Model: AP-C2	Date: 10-Sep-08	No.: RD029001b
--------------	-----------------	----------------

Subject: Firmware Release Note: Language Install		Prepared by: T.Kiyohara	
From: 2nd Tech. Support Sec. Service Support Dept.			
Classification:	<input type="checkbox"/> Troubleshooting	<input type="checkbox"/> Part information	<input type="checkbox"/> Action required
	<input type="checkbox"/> Mechanical	<input type="checkbox"/> Electrical	<input type="checkbox"/> Service manual revision
	<input type="checkbox"/> Paper path	<input type="checkbox"/> Transmit/receive	<input type="checkbox"/> Retrofit information
	<input type="checkbox"/> Product Safety	<input checked="" type="checkbox"/> Other ()	<input checked="" type="checkbox"/> Tier 2

This RTB has been issued to announce the firmware release information for the **Language Install**.

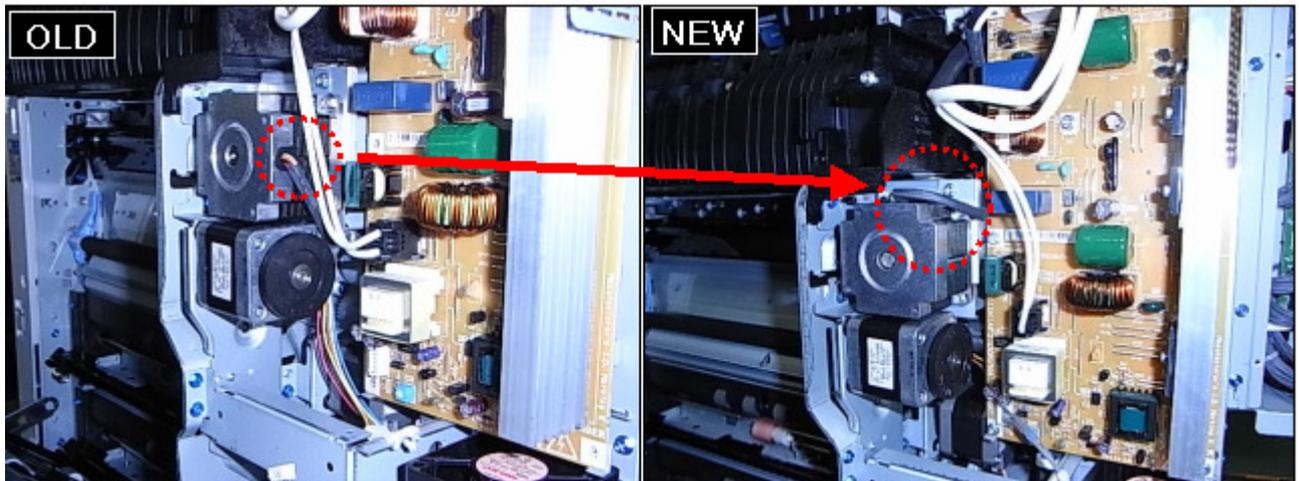
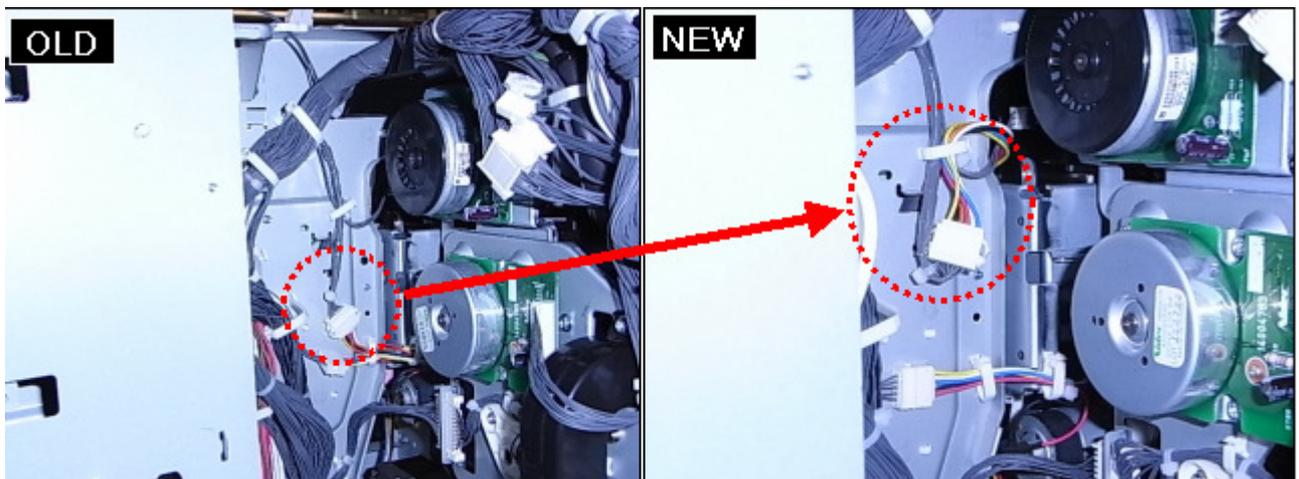
13. Attach the pressure roller contact motor [I] (screw x 4) in the “NEW” orientation shown below.

Important: Make sure that the opening in the pressure contact motor for the harness is **facing up** (and not right). This is to prevent the harness from touching the wheel of the duplex bypass motor.

14. Change the harness clamps to the “NEW” orientation shown below.

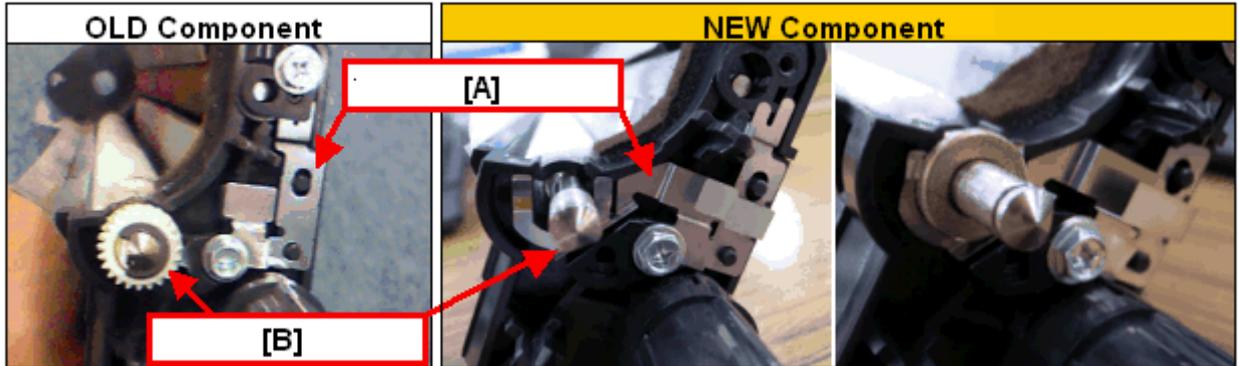
- The shape of the GND plate [A] was changed so that there is another contact point between the GND plate and the lubricant application shaft [B].

Applied from: January 2010 production

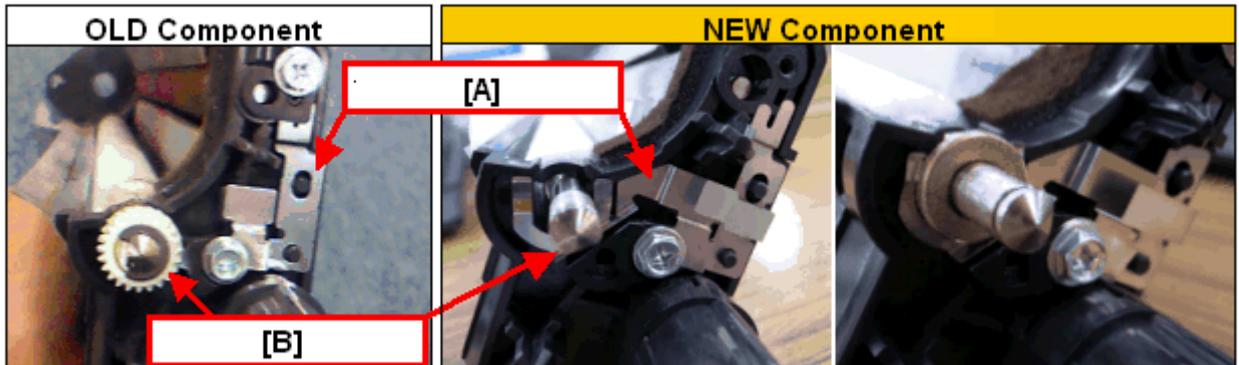
- The shape of the GND plate [A] was changed so that there is another contact point between the GND plate and the lubricant application shaft [B].

Applied from: March 2009 production

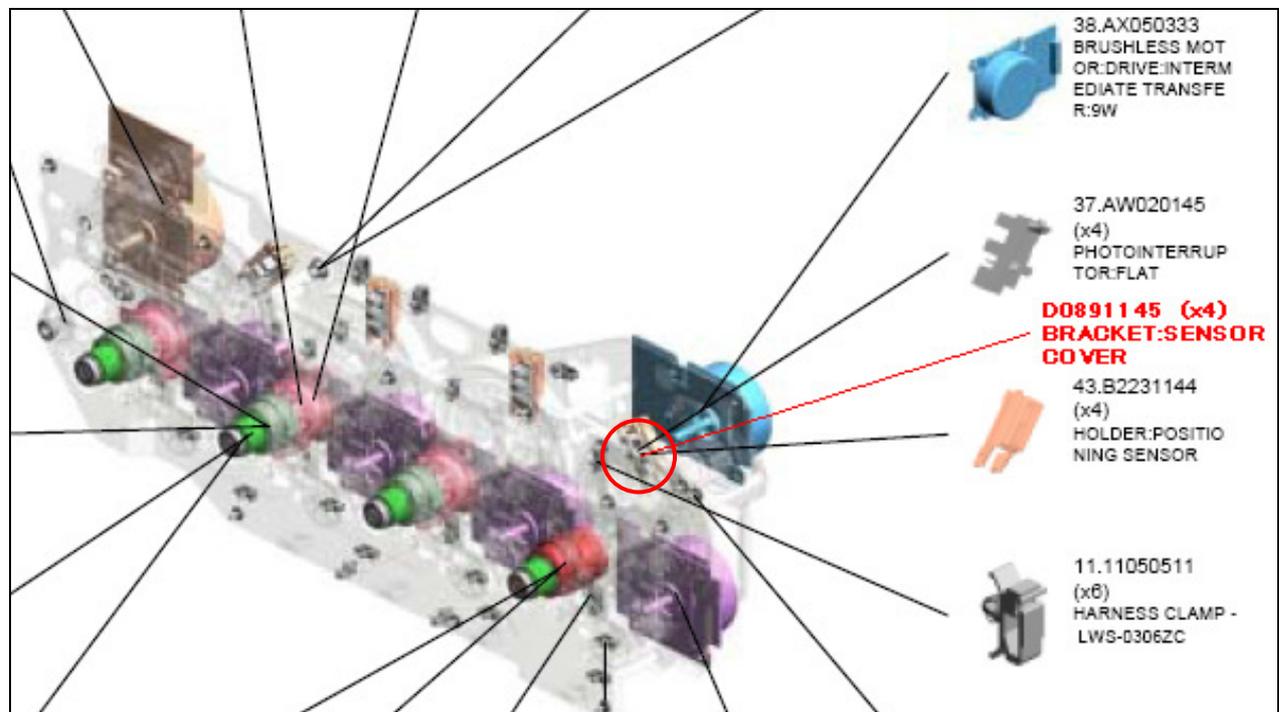
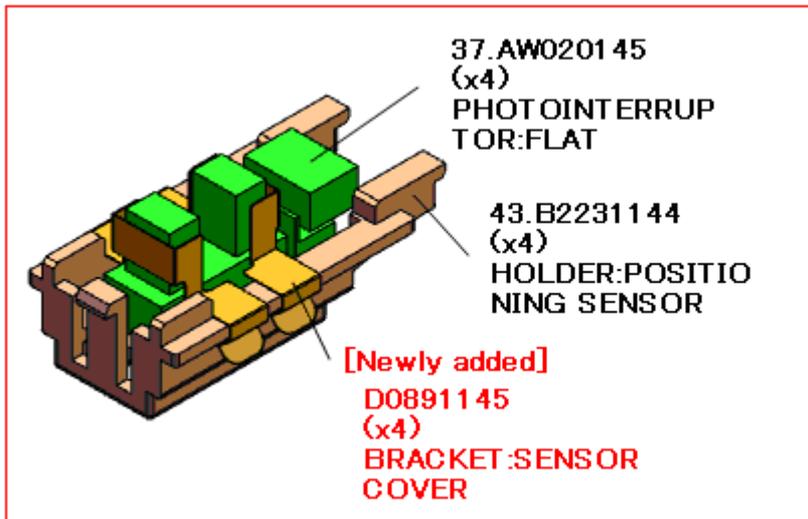
Change: *The phase control positioning sensor ass'y was added as a new part.*
 A sensor cover was added to the phase control positioning sensor.

Reason: To avoid electrostatic influence from drum gear.

[Newly added]
D0891135
(x4)
POSITIONING
SENSOR: DRUM :
ASS'Y

Fig. 1

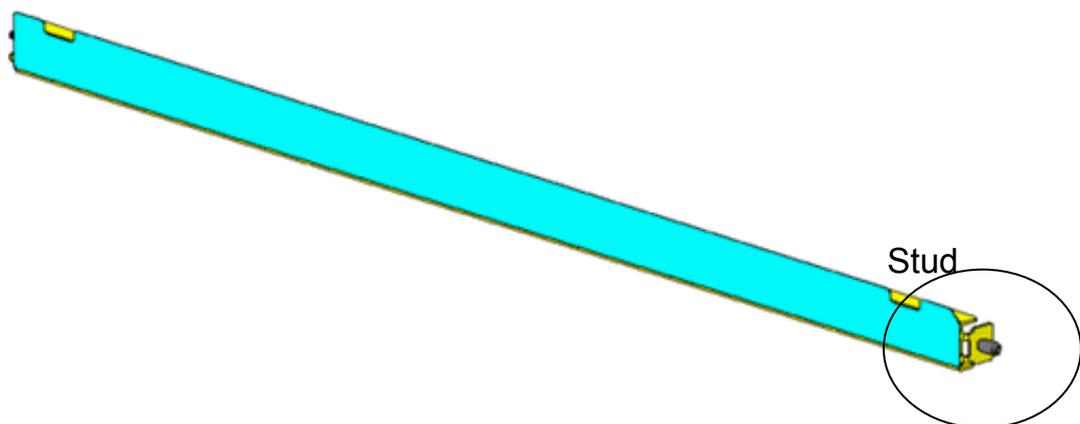
Reason: To prevent paper jams by minimizing the range of motion (twisting) of the stay.
